# CITY OF NEWPORT BEACH

## BUILDING DEPARTMENT

### SWIMMING POOL/SPA CORRECTION LIST

**Figure 1**

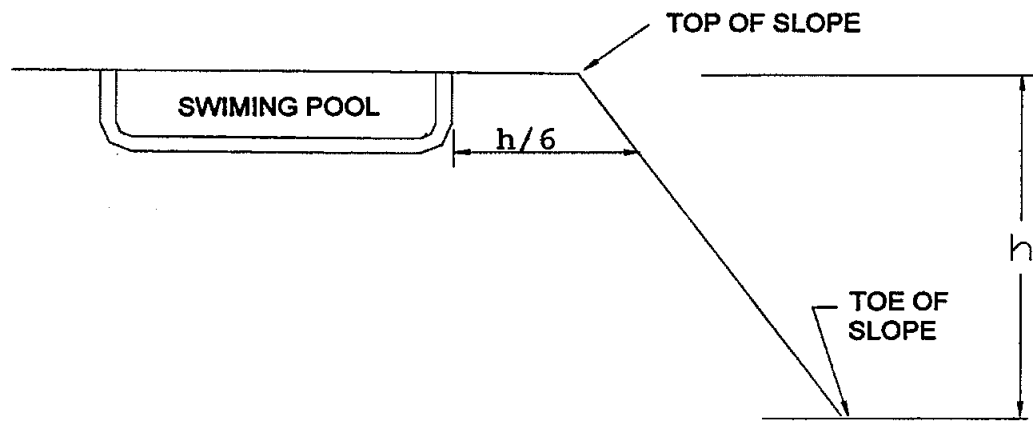
- 25. Provide material specifications for:
  - a. Concrete
  - b. Steel
- 26. Dimension the pool setback from the top of the adjacent slope, and the height of the slope. The face of the pool wall at the base of the wall shall be h/6 ft. away from the face of the slope. CBC 1805.3.3 See Figure 1 on the last page.
